**Major Permit Modification Application
Yarnell Road Demolition Landfill
DML 47 000 0069**

Subject: Major Permit Modification Application
Phase F-2 Final Cover Grades
Yarnell Road Demolition Landfill, DML 47-0069

Subject: Response to Technical Review – Proposed Major Permit Modification
Notice of Deficiency - Yarnell Road Demolition Landfill, DML 47-0069

ANTI - SEEP COLLAR
NTS

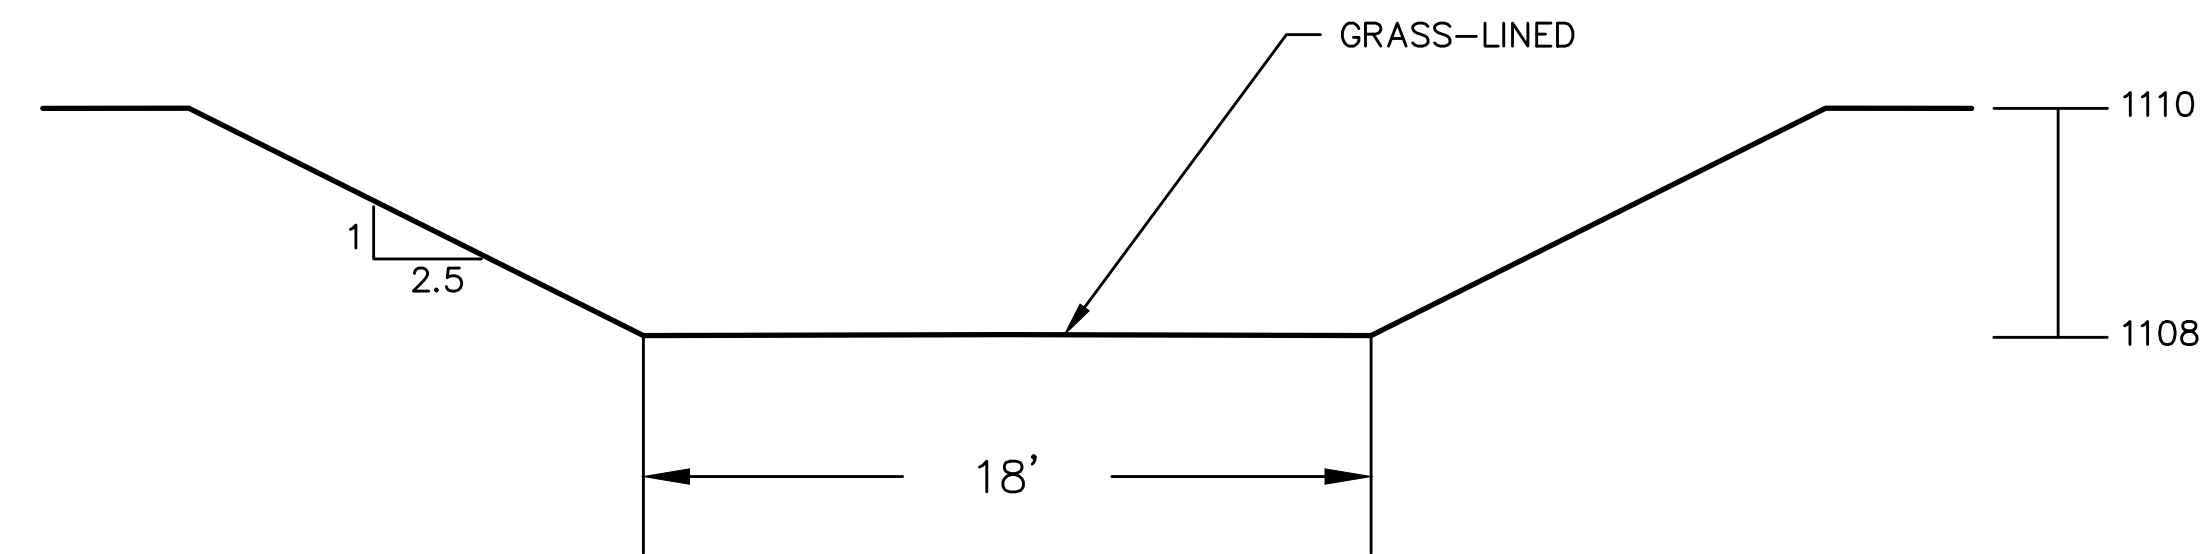
- **Need to add an anti-seep collar detail**

An anti-seep collar detail was added to Sheet 10.

SEDIMENT BASIN FOREBAY DETAIL (3)
 NTS (5/11)

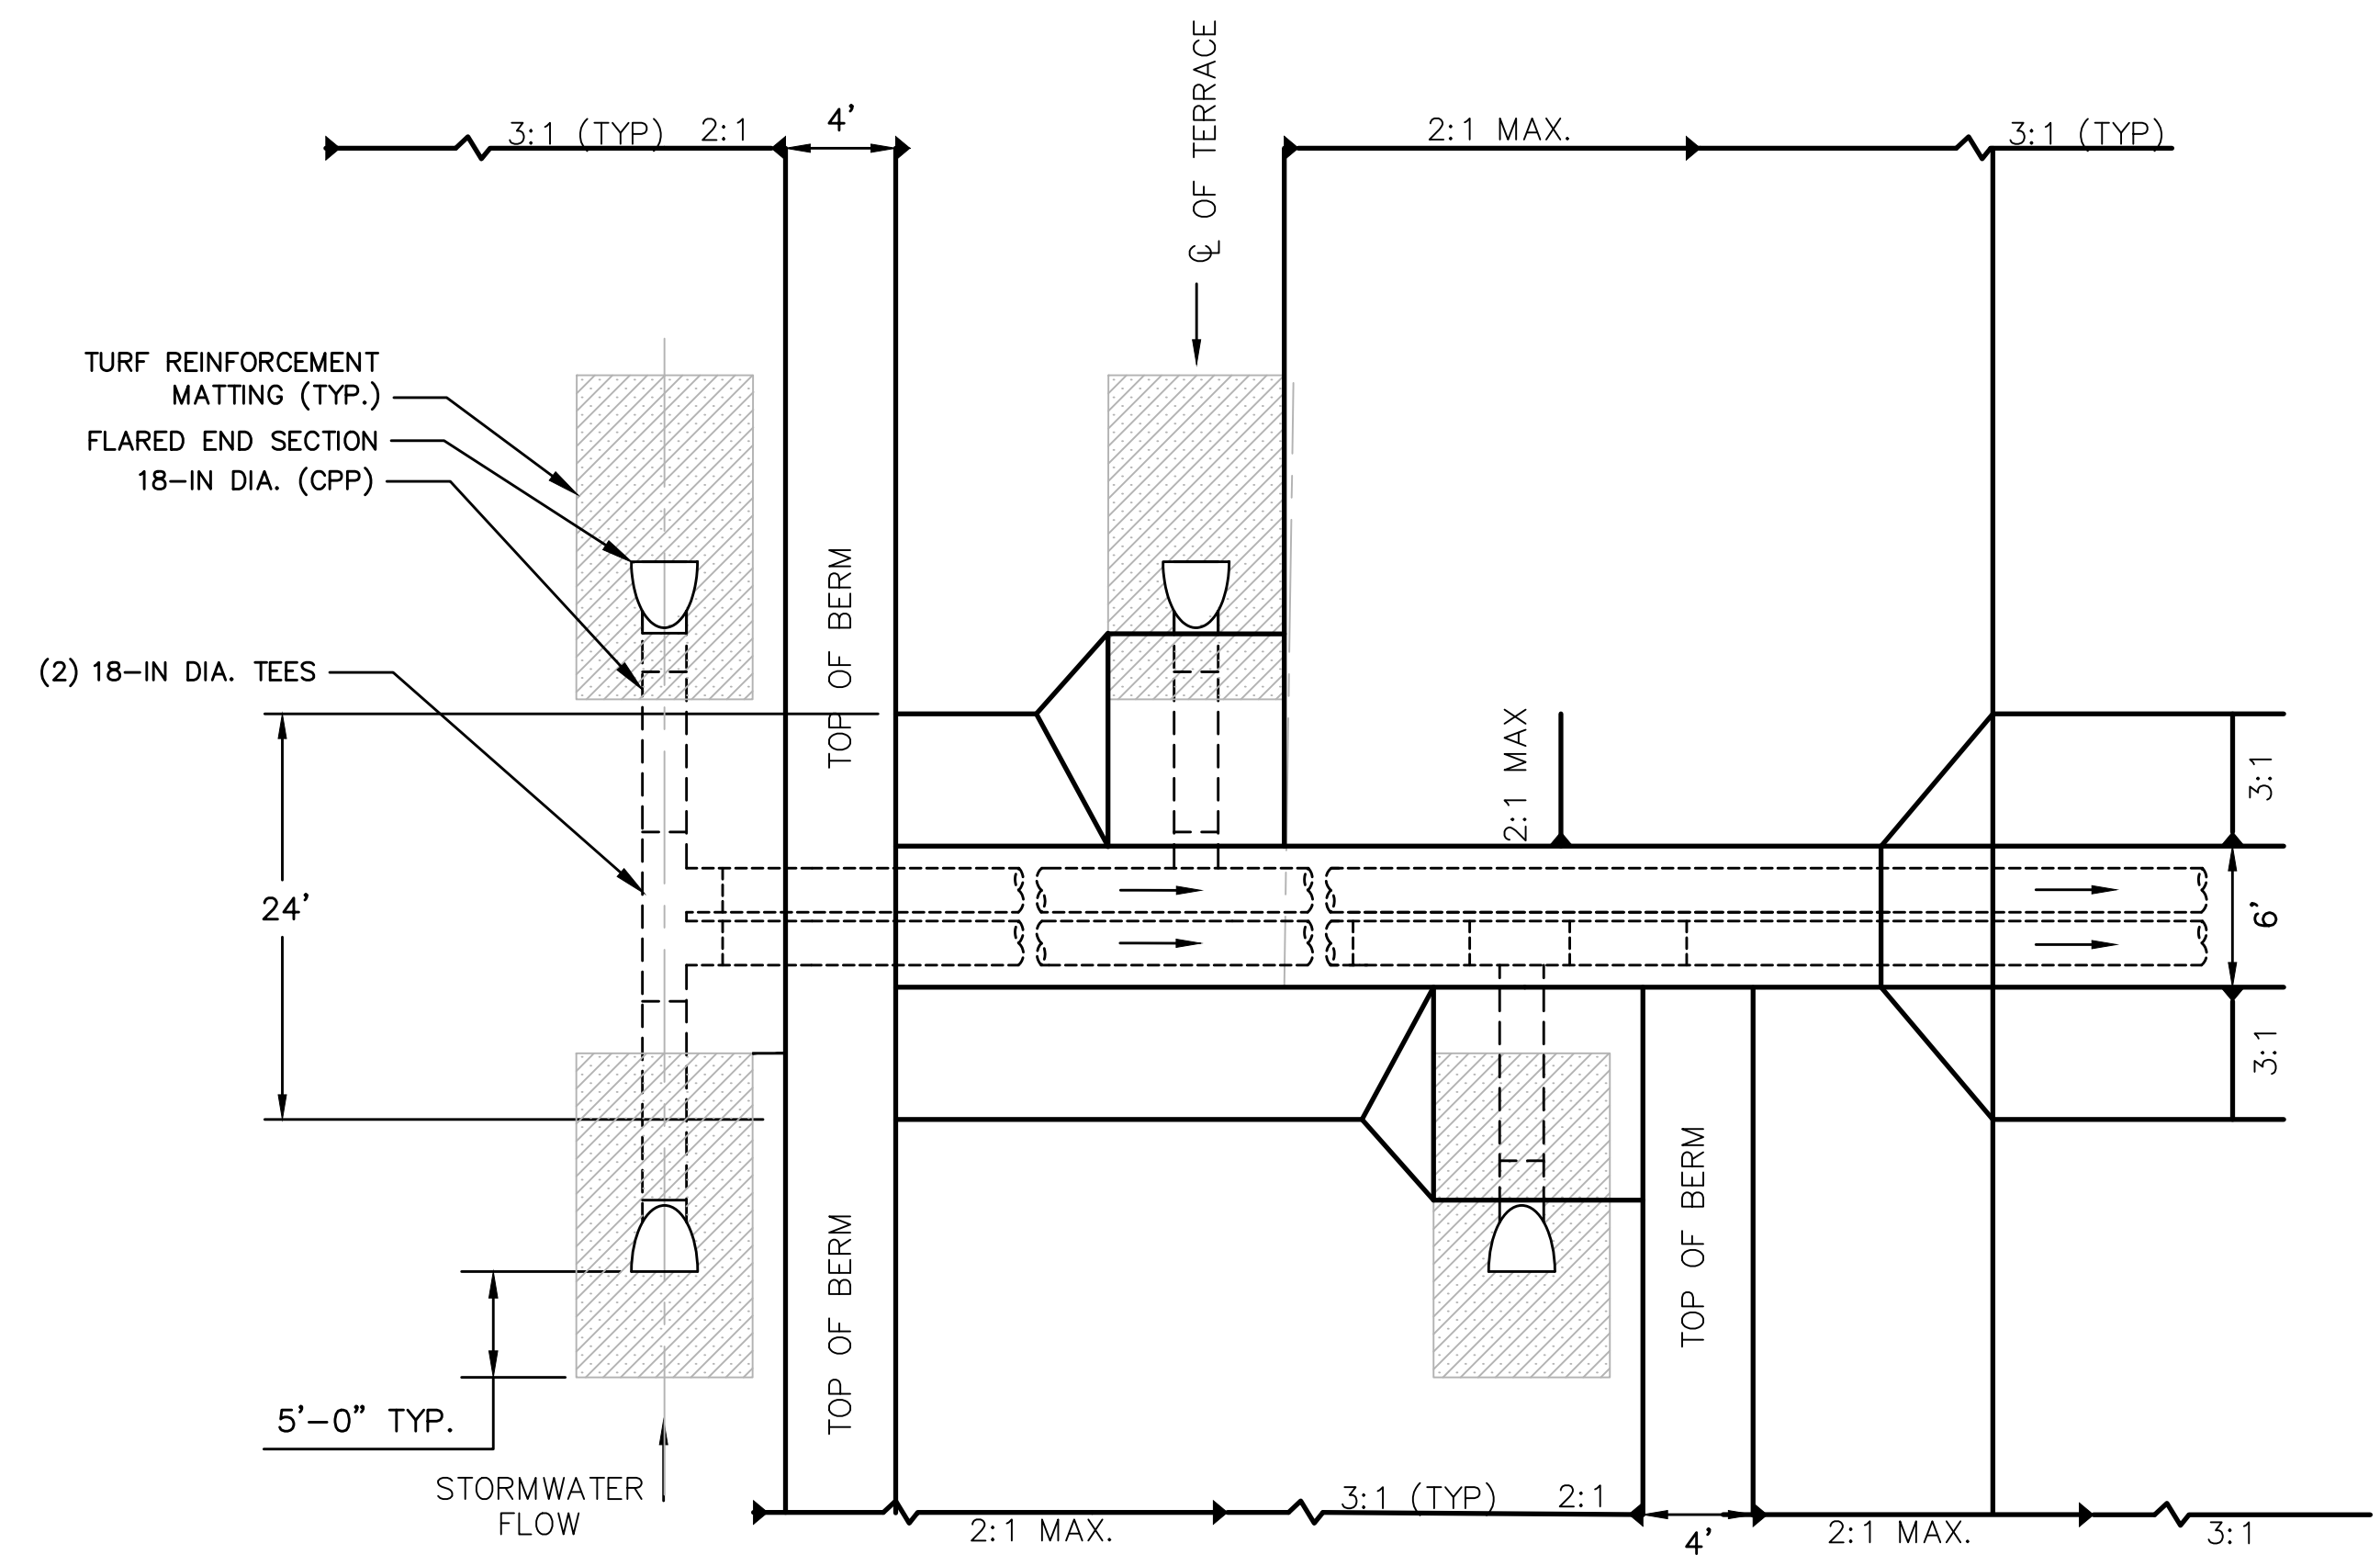
28. Need to add a sedimentation forebay to the sediment pond 3.

- **Add maximum elevation of both the 25-yr, 24-hr and 100-yr, 24-hr storm events.**

A sediment forebay has been added to Sediment Basin 3 on Sheet 5. See Detail 3, Sheet 11 for a detail of the forebay.

The maximum elevations of the 24-hour/25-year and 24-hour/100-year storm events have been added to Detail 3, Sheet 11.

DOUBLE DOWNCHUTE DRAIN PIPE & SIDESLOPE DRAINAGE BERM INLET CONNECTION DETAIL (2)
 NTS (5/11)

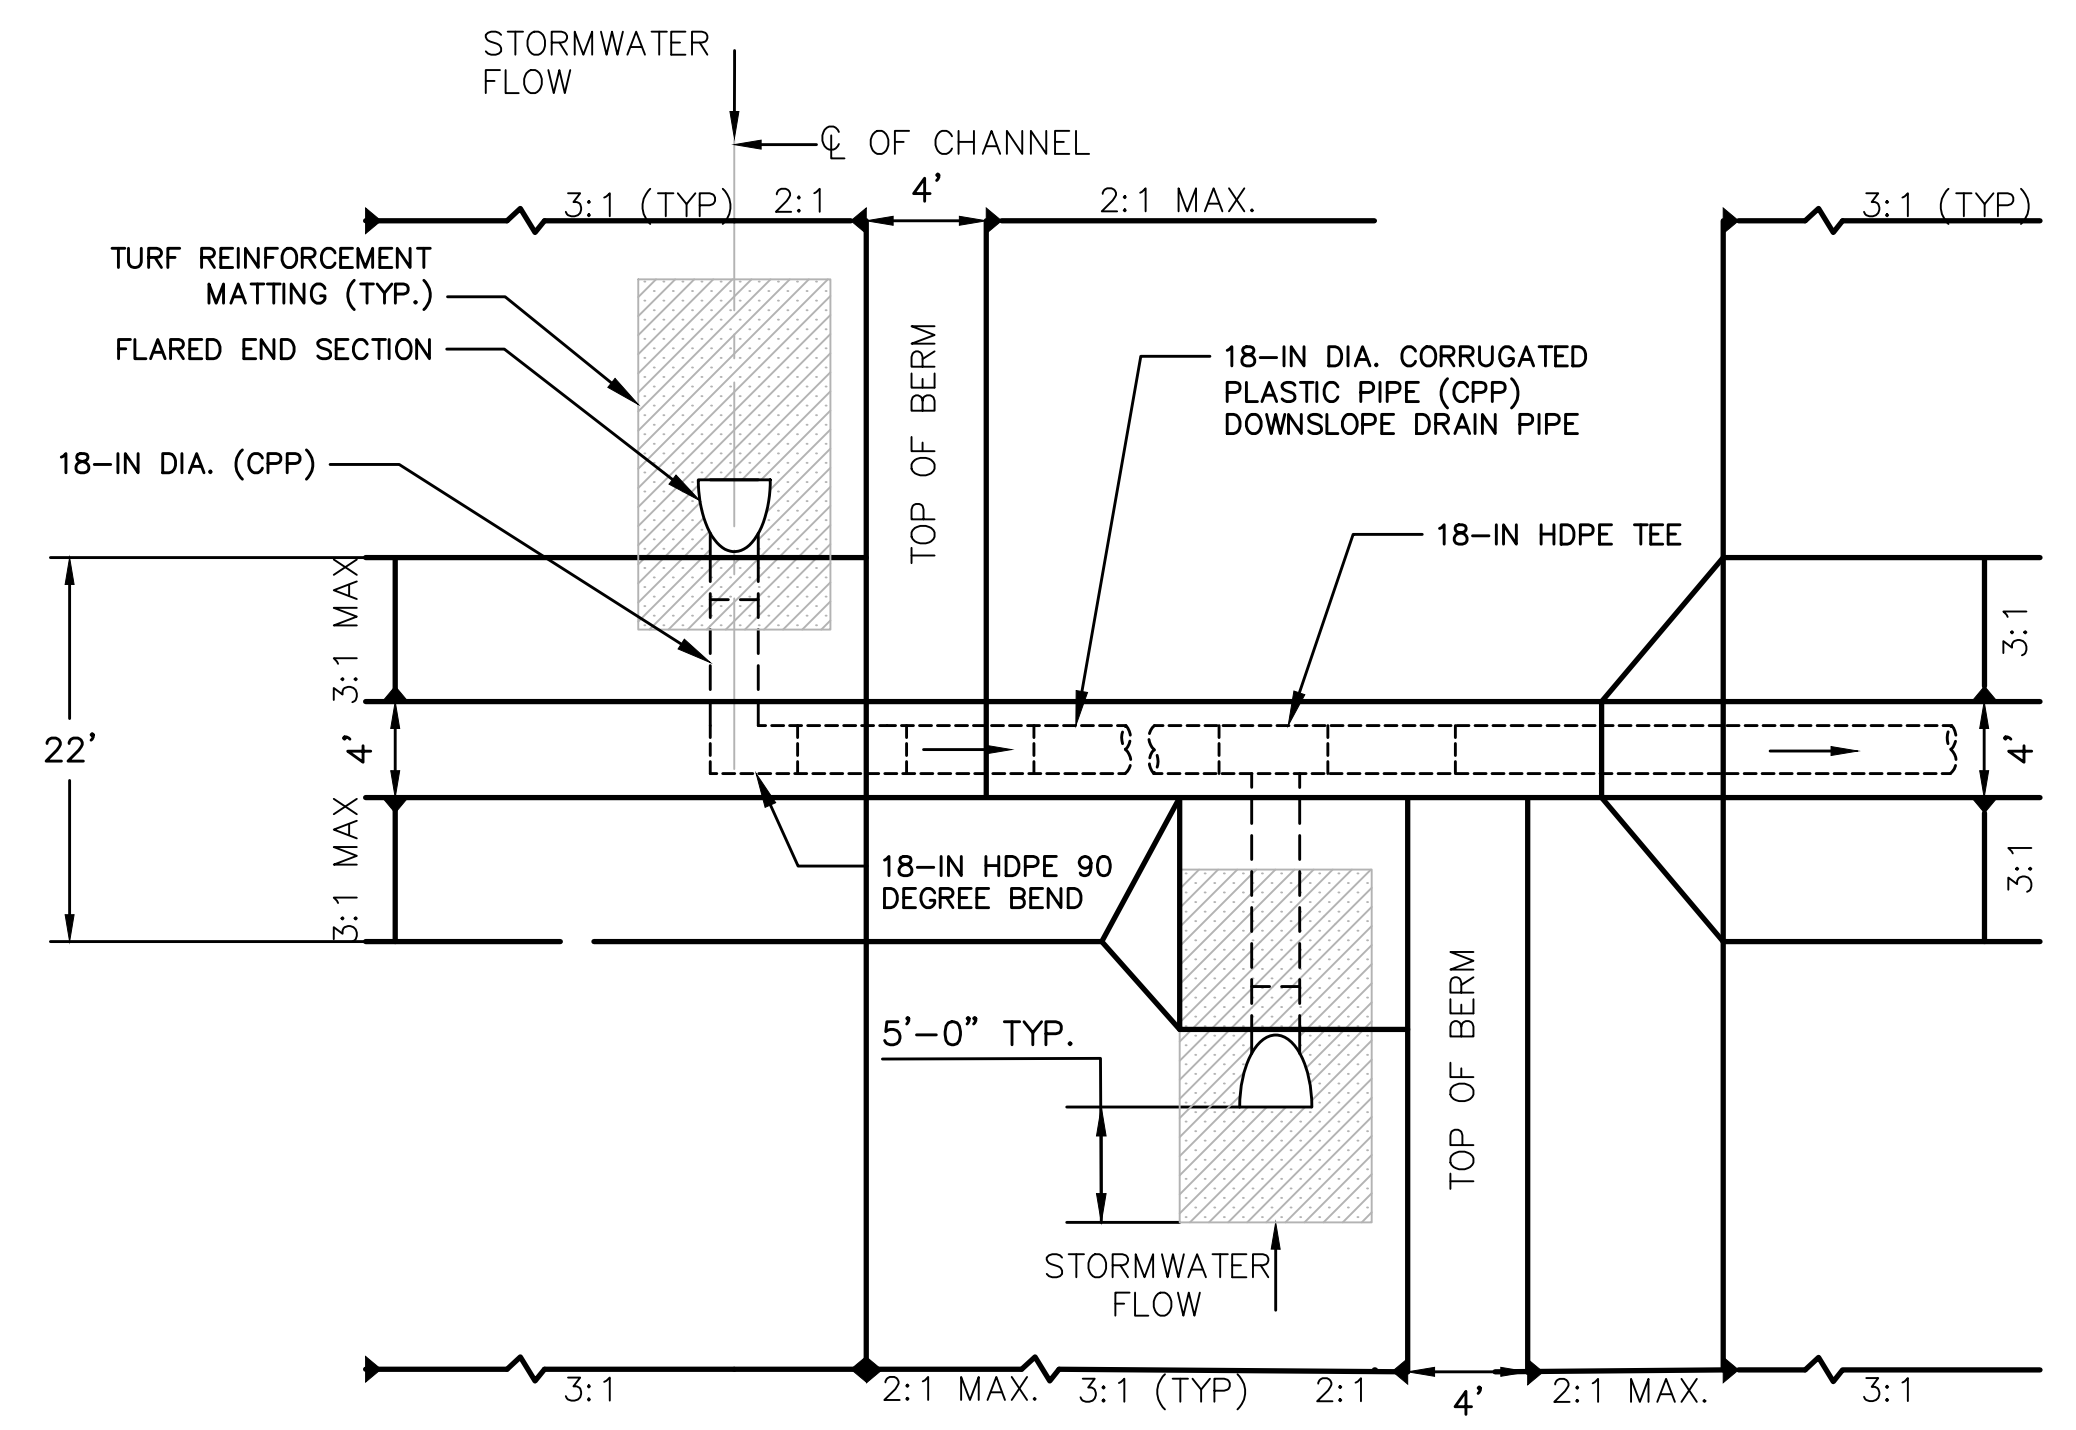
- 9. Will the stormwater flow from the side slope terrace into the proposed (2) 24-inch pipes? If so, please explain how. A detail should be provided.**

11. Will flow from TB-5 get into (2) 18-inch pipes? If so, please explain how. A detail should be provided.

24-inch diameter pipes are only located from the drop inlet to the outfall into Sediment Basin 3. Detail 2, Sheet 11 shows how the side slope terrace will flow into the 18-inch diameter pipe.

Detail 2, Sheet 11 shows how TB-5 will flow into the 18-inch diameter pipe.
